Proposal for the 03 series of amendments to UN Regulation No. 100 (Specific requirements for the electric power train)

Submitted by the experts from Japan on behalf of Task Force

The text reproduced below has been prepared by the experts from Japan on behalf of Task Force to amend the requirements concerning specific requirements for the electric power train. The modifications to the current text of the Regulation and to the proposal are marked in bold for new or strikethrough for deleted characters.

Figure 1
Schematics of how to measure wrap-around distance

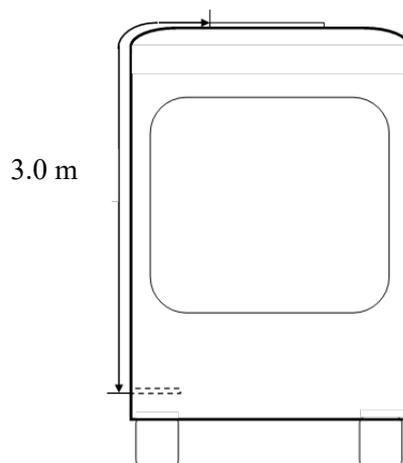
For vehicles of categories N2, N3, M2 and M3, conductive connection devices not energized except during charging of the REESS are exempted from this requirement if located on the roof of the vehicle out of reach for a person standing outside of the vehicle and, for vehicles of category M2 and M3, the minimum wrap around distance from the instep of the vehicle to the roof mounted charging devices is 3.00 m. In case of multiple steps due to elevated floor inside the vehicle, the wrap around distance is measured from the bottom most step at entry, as illustrated in Figure 1.

Figure 1
Example of test method using DC power supply

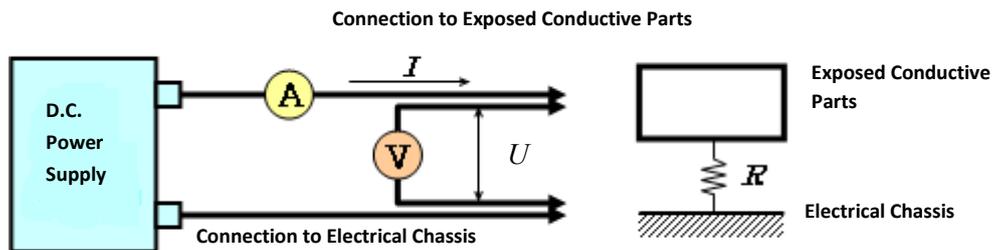
2. Test method using DC power supply, voltmeter and ammeter.

Example of the test method using DC power supply, voltmeter and ammeter is shown below.

Figure 1
Standard nozzle for the test

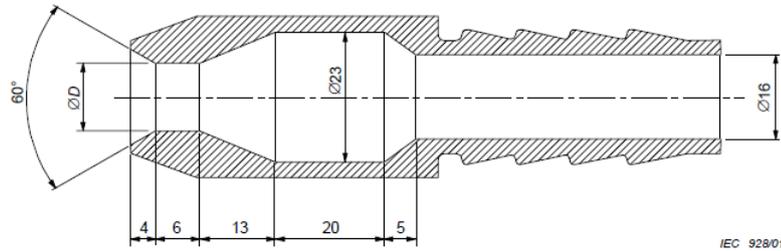
- 2.2. For electrical components, externally attached (e.g. in engine compartment), open underneath, both exposed or protected locations, the testing authority shall verify, with a view to confirming the compliance, whether the test is conducted by spraying the high-voltage component or system from all practicable directions with a stream of water from a standard test nozzle as shown in Figure 1. The following parameters are observed during the test in particular:

- (e) Minimum test duration: 3 min;

- (f) Distance from nozzle to tested high-voltage component or system surface: approximately 3 m (this distance may be reduced, if necessary to ensure proper wetting when spraying upwards).
